May 7, 2010

Re: Public Comments about the NMED Hazardous Waste Permit for LANL

Concerned Citizens for Nuclear Safety (CCNS) submits the following public comment for the proposed New Mexico Environment Department (NMED) ten-year hazardous waste permit for Los Alamos National Laboratory (LANL). We submit the following documents and figures into the administrative record, as noted by their "exhibit" or "figure" number:

Figure 4-33. Predicted plume migration for sources released at the water table below Mortandad Canyon, based on a steady-state, with pumping, flow field.

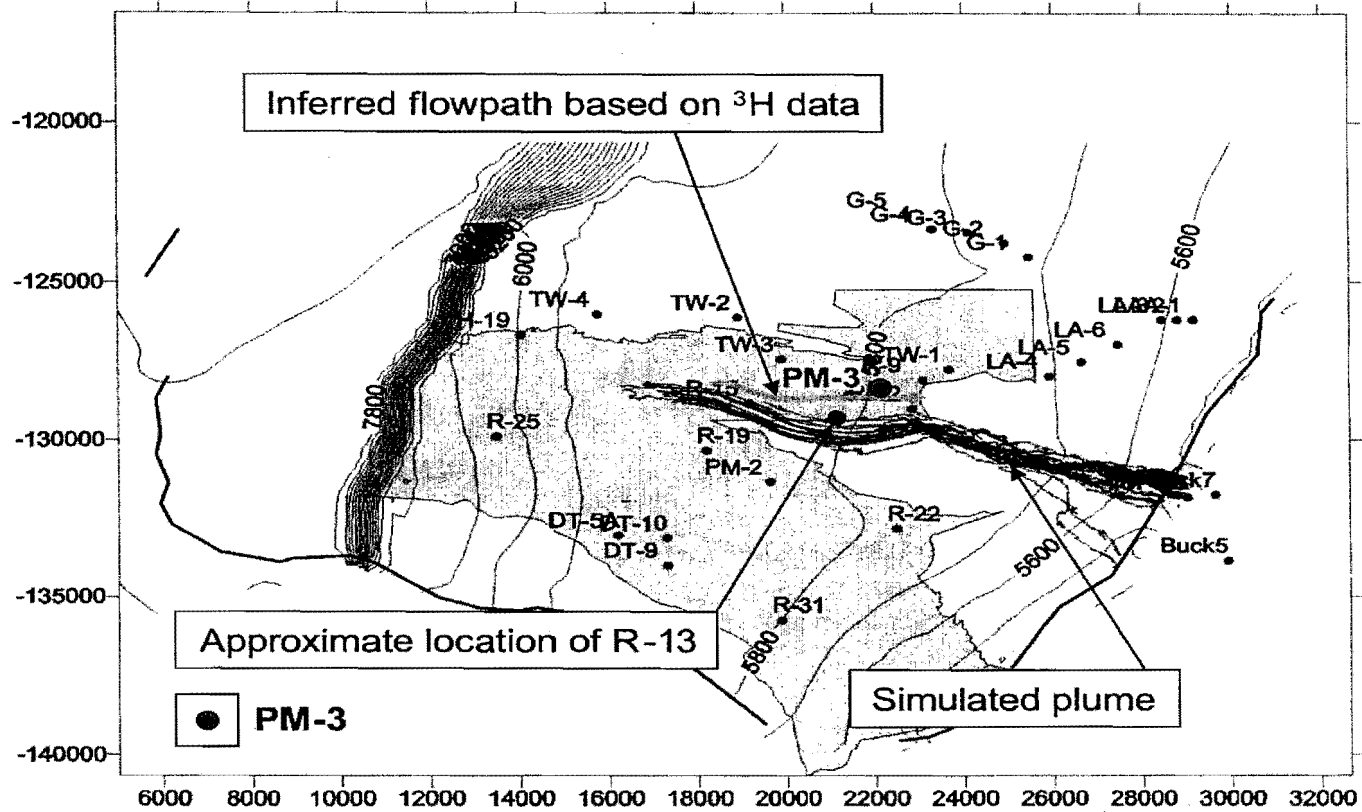
2. Over three years ago, LANL found elevated levels of chromium in regional characterization well R-28. LANL computer modeling predicts the plume reaches the Los Alamos County and City of Santa Fe drinking water wells. See Figure 4-33, which is attached as Attachment 1. Predicted plume migration for sources released at the water table below Mortandad Canyon, based on a steady-state, with pumping, flow field. Los Alamos National Laboratory's Hydrogeologic Studies of the Pajarito Plateau: A Synthesis of Hydrogeologic Workplan Activities (1998-2004), LA-14263-MS, p. 4-54. Despite the LANL modeling, we still do not know the dimensions of the plume or how fast it is moving toward the drinking water wells.

As-Built Schematic for LANL Characterization Well R-16

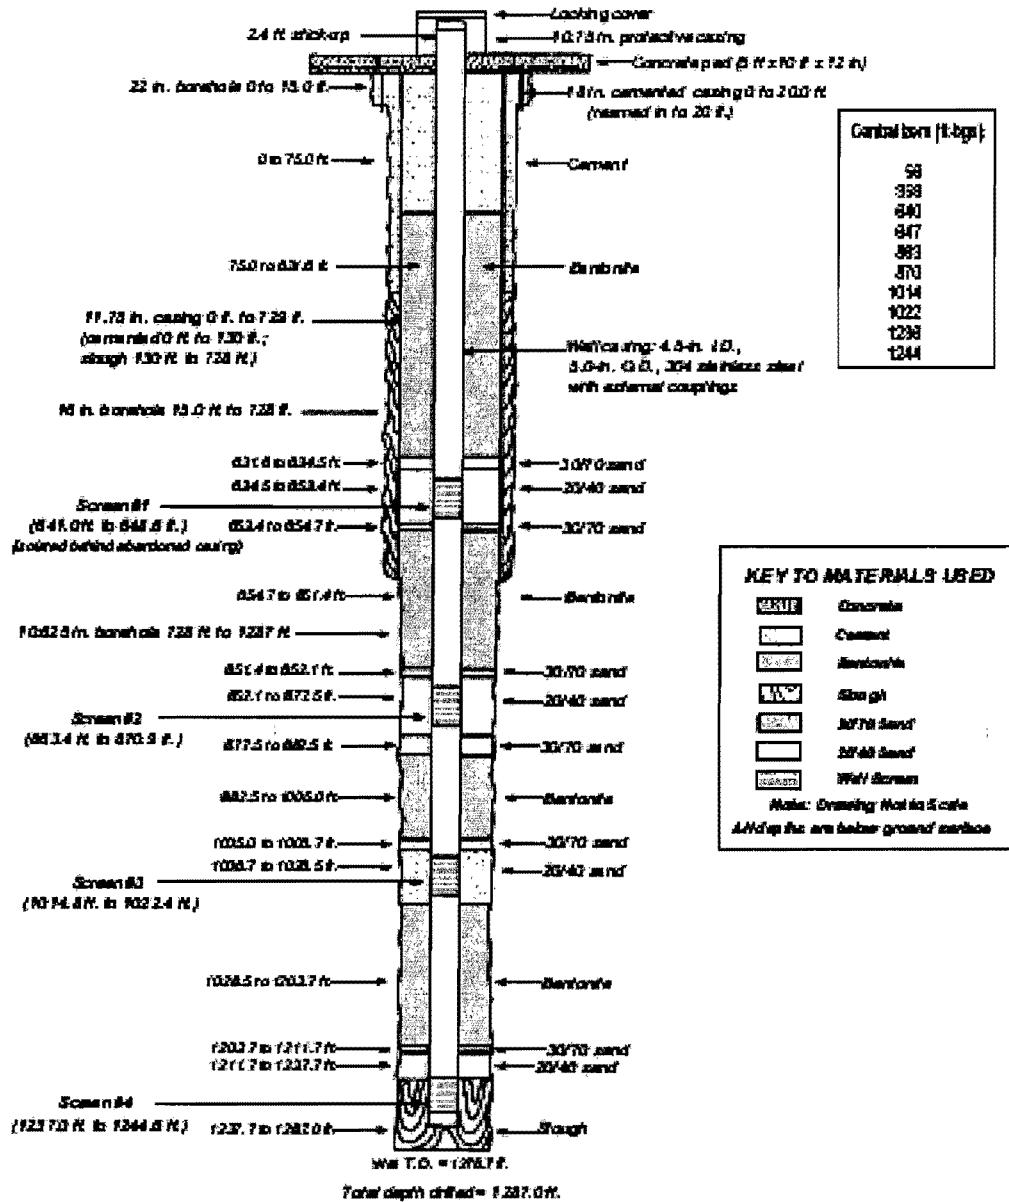
An additional problem is that the Schlumberger[®] borehole geophysics report, included as an appendix in the LANL Well R-16 Completion Report, shows that the well screens are not installed in the strata with highest permeability, the aquifer strata that are the fast pathways for contaminants to travel to the Buckman Wellfield. There are many factors that require replacement of Well R-16.

Figure 1. Source: Figure 3.2-6 in LANL Report MDA G CME Report – Rev 1 (LA-UR-09-5509 September 2009). AR 32022.

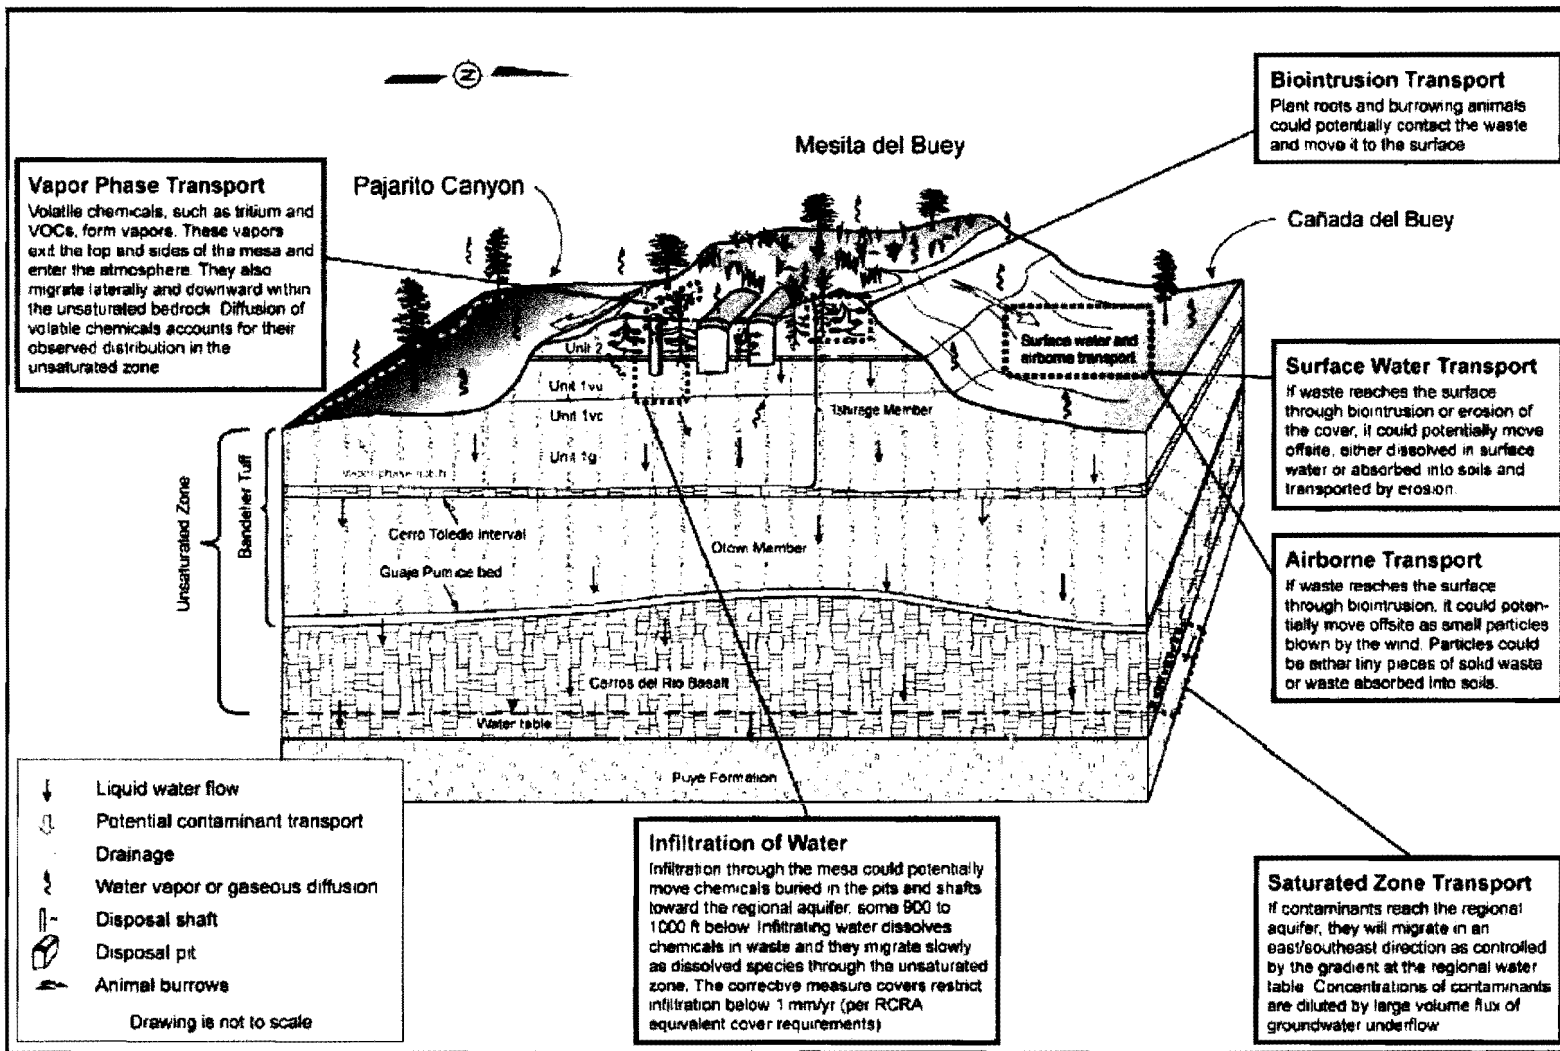
Figure 1. Source: Figure 3.2-6 in LANL Report *MDA G CME Report – Rev 1* (LA-UR-09-5509 September 2009). (AR 32022)

Figure 3. Schematic of locations for “point of compliance” contaminant detection monitoring wells and upgradient background water quality wells for RCRA “regulated units.”

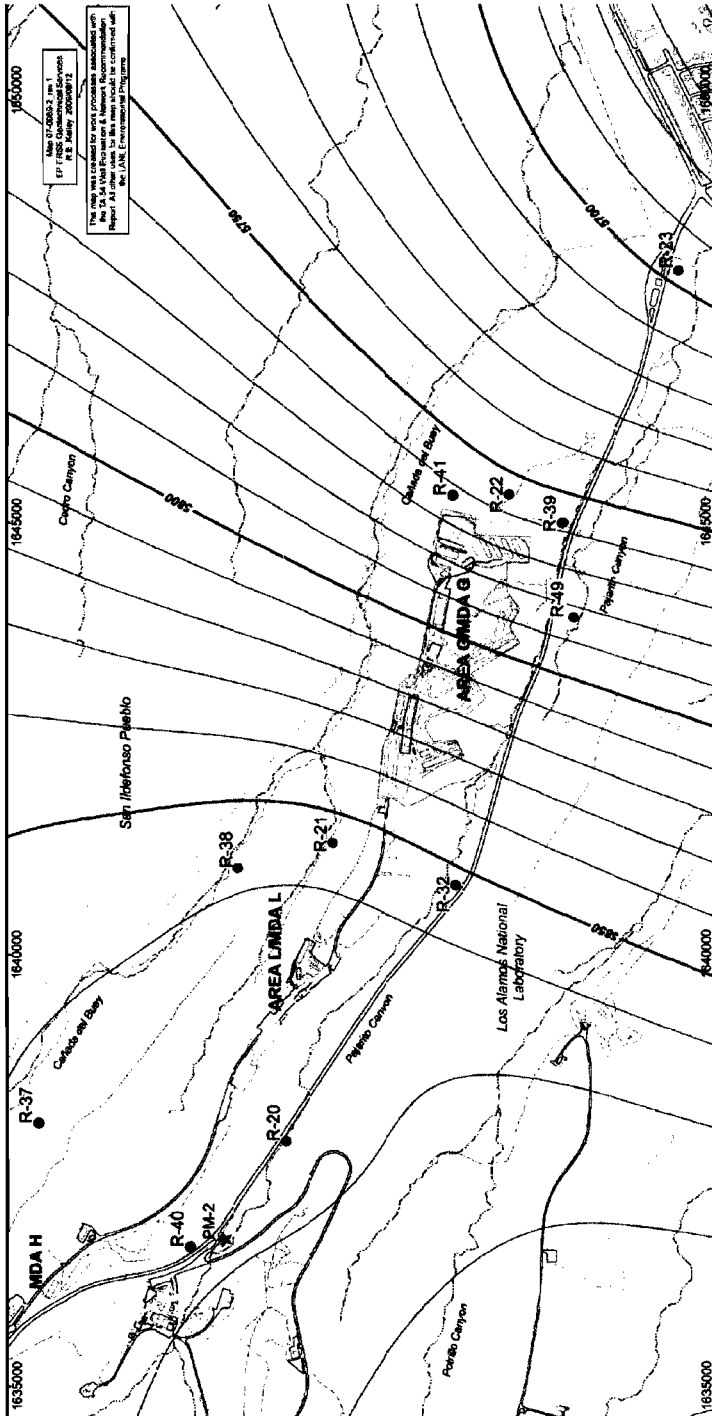
- The distance from the northern boundary of MDA L to well R-38 is ~ 1/4 mile
- The contour lines are the elevation of the water table of the regional aquifer
- The direction of groundwater flow below MDA G is to the southeast.
- The R-wells are the monitoring wells installed in the regional aquifer.

Figure 4. The NMED requirements for the network of monitoring wells at the Sandia National Laboratories Mixed Waste Landfill in Albuquerque, New Mexico.

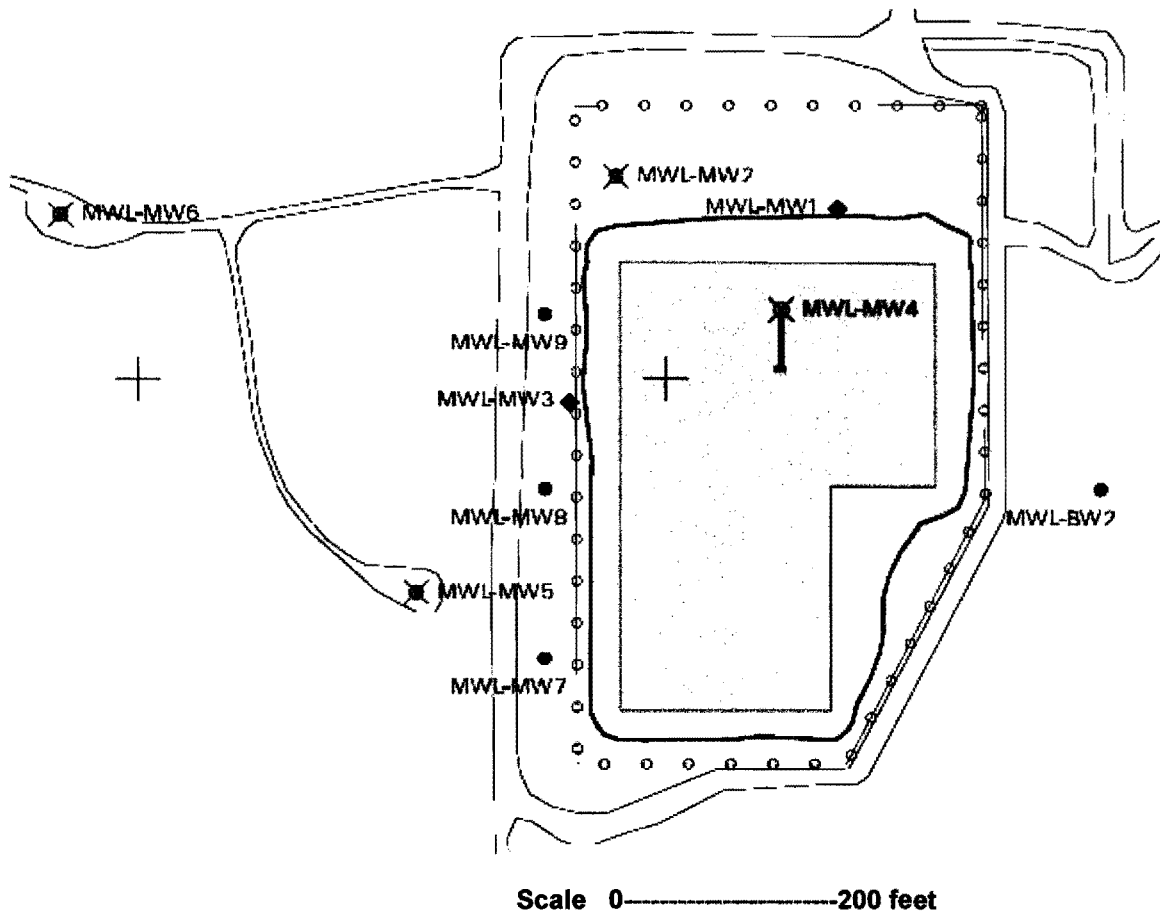
- The down-gradient detection monitoring wells required for the long-term monitoring program are MWL-MW5, -MW6, -MW7, -MW8 and -MW9.
- Well MWL-MW4 is a detection monitoring well installed inside the Mixed Waste Landfill to monitor groundwater contamination below an unlined trench.
- Well MWL-BW-2 is the background water quality well that is located hydraulically upgradient of the Mixed Waste Landfill.
- The 2.6 acre Mixed Waste Landfill was in operation from 1959 through 1988. The hazardous and mixed waste are buried in unlined pits and trenches. The NMED has approved a plan to leave the wastes buried below a dirt cover.

Figure 5. The NMED requirements for the network of monitoring wells at the Sandia National Laboratories Chemical Waste Landfill in Albuquerque, New Mexico.

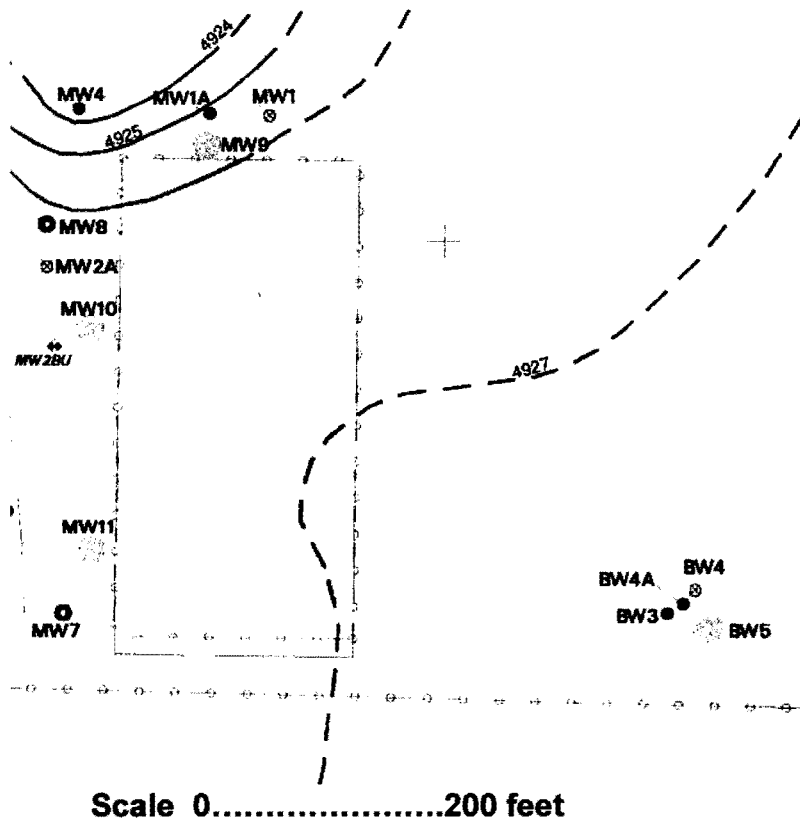
- The Chemical Waste Landfill is a RCRA “regulated unit” waste disposal facility.

- MW-9, MW-10 and MW-11 Contaminant detection monitoring wells
- BW-5 Background water quality monitoring well

Figure 6. Location of Three Volatile Organic Compound (VOC) Vapor Plumes at Los Alamos National Laboratory Legacy Waste Dump MDA G.

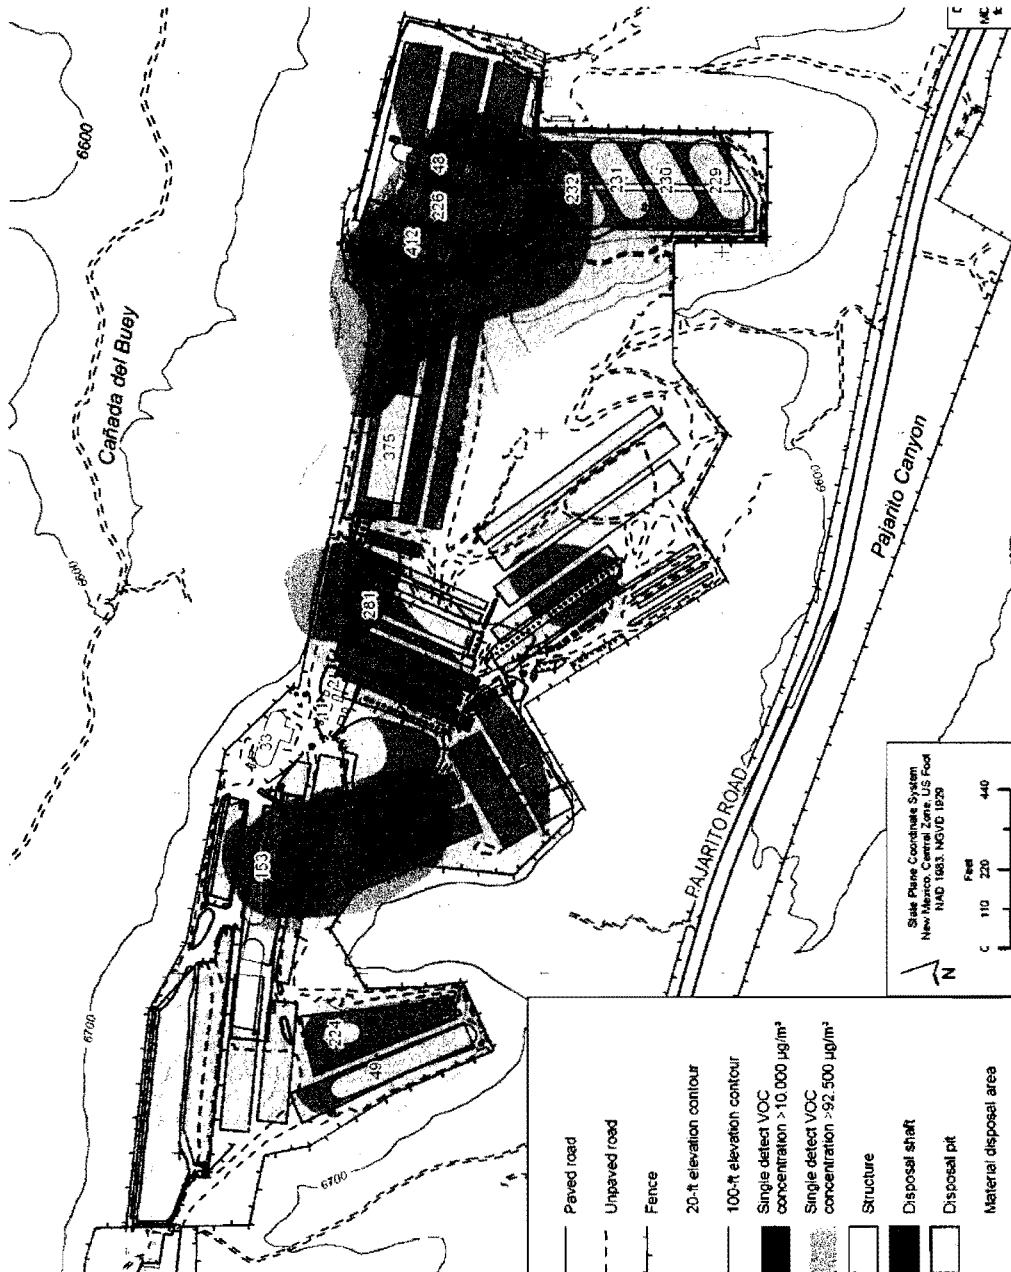
- The three VOC plumes are colored brown and are present in the eastern, central and western parts of MDA G. The highest VOC concentrations are in the eastern plume at the shaft field that is located west of pits 2 and 4 ~ 700 feet from the eastern boundary of MDA G. Pits 2 and 4 are identified on Figure 2. The dominant subsurface VOC vapor contaminant is 1,1,1-trichloroethane (TCA) in the eastern and central portion of MDA G; trichloroethene (TCE) is more dominant in the western portion of MDA G.
